Public Input No. 260-NFPA 70-2020 [Global Input]

Statement of Problem and Substantiation for Public Input

Committee Statement

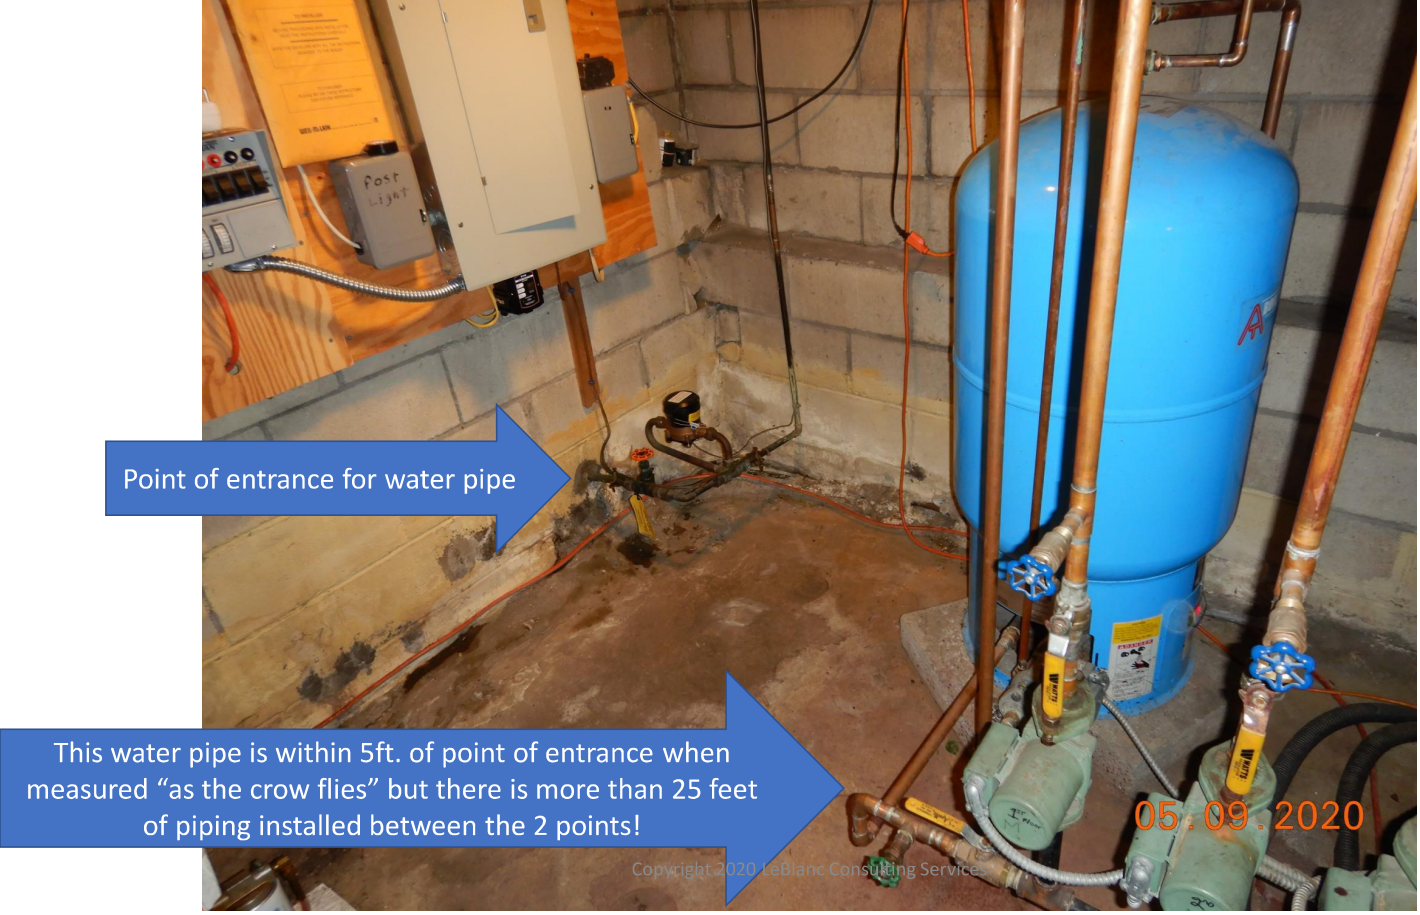
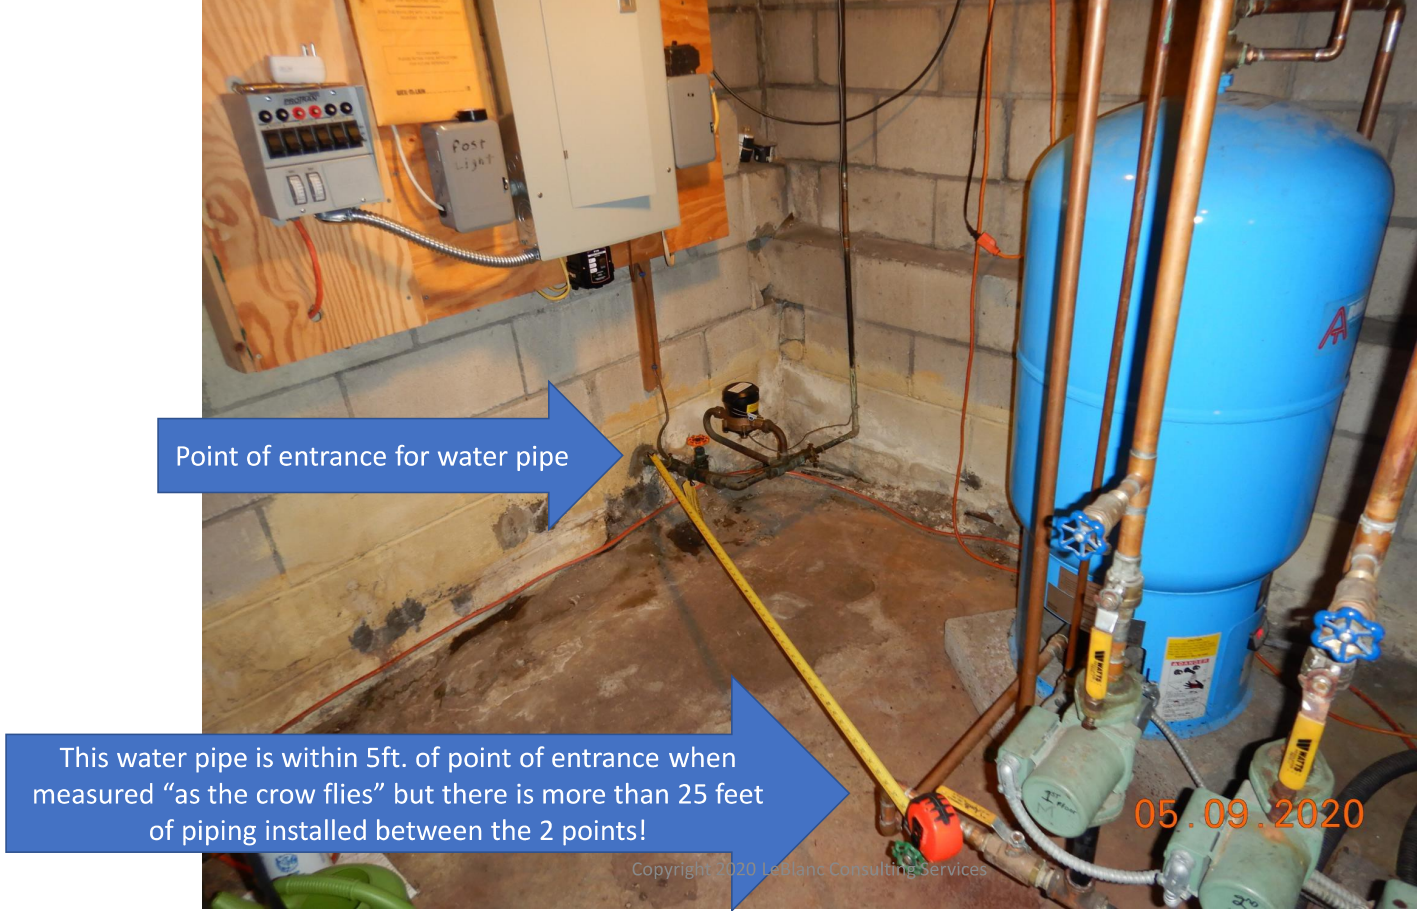
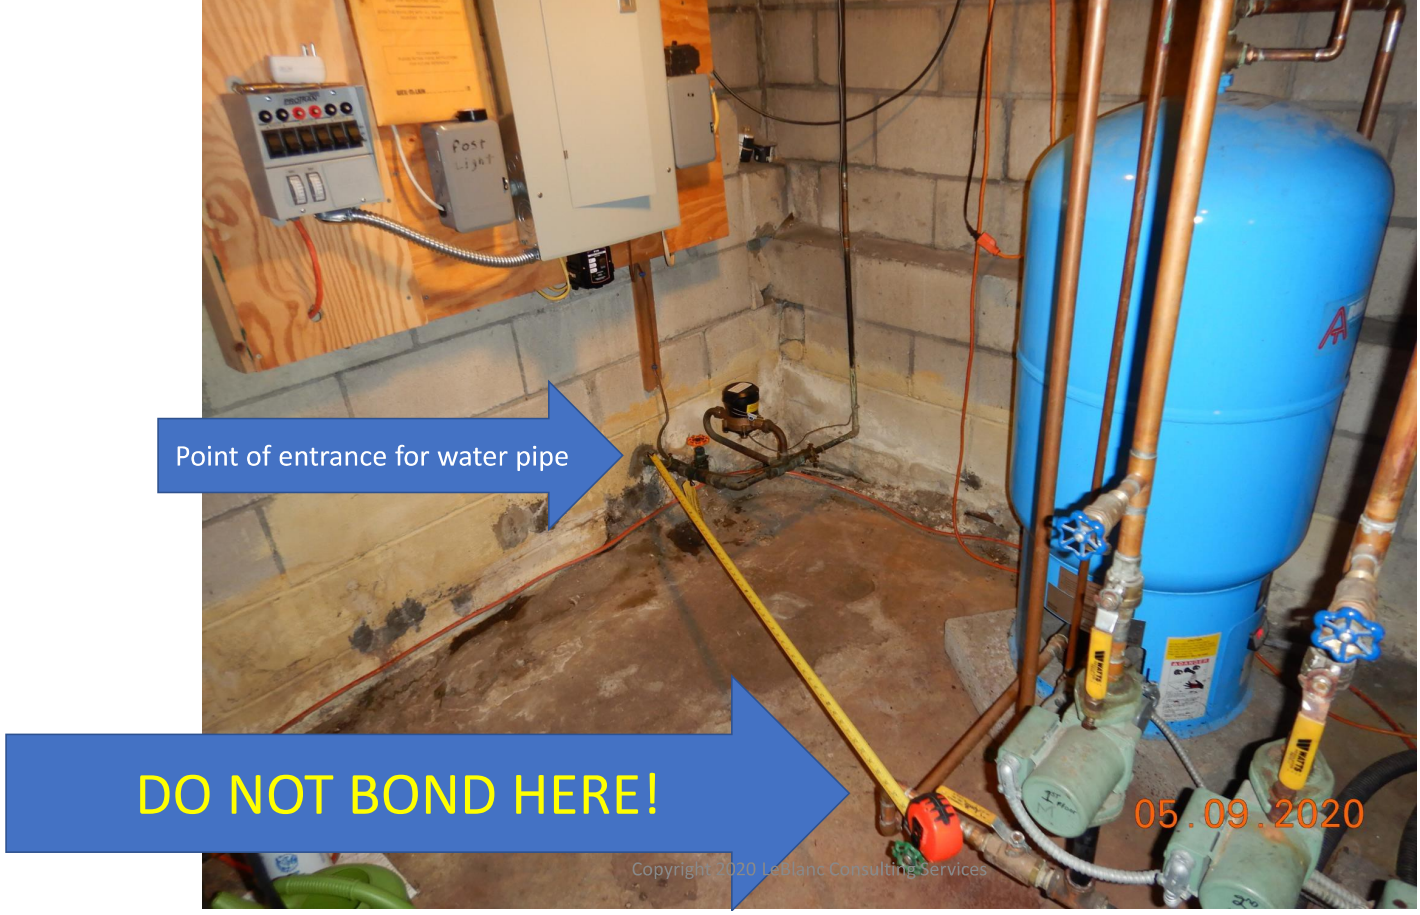
- Should be measured “along the water pipe”!
- Should NOT be measured “as the crow flies”!

Point of entrance for water pipe
This water pipe is within 5ft. of point of entrance when measured “as the crow flies” but there is more than 25 feet of piping installed between the 2 points!
05 . 09 . 2020
Copyright 2020 LeBlanc Consulting Services

Point of entrance for water pipe
This water pipe is within 5ft. of point of entrance when measured “as the crow flies” but there is more than 25 feet of piping installed between the 2 points!
05.09.2020
Copyright 2020 Leblanc Consulting Services

This water pipe is within 5ft. of point of entrance when measured “as the crow flies” but there is more than 25 feet of piping installed between the 2 points!

Point of entrance for water pipe
DO NOT BOND HERE!
05.09.2020
Copyright 2020 Leblanc Consulting Services

Measure 5ft. “along the water pipe”!
Point of entrance for water pipe
05.09.2020
Copyright 2020 LeBlanc Consulting Services
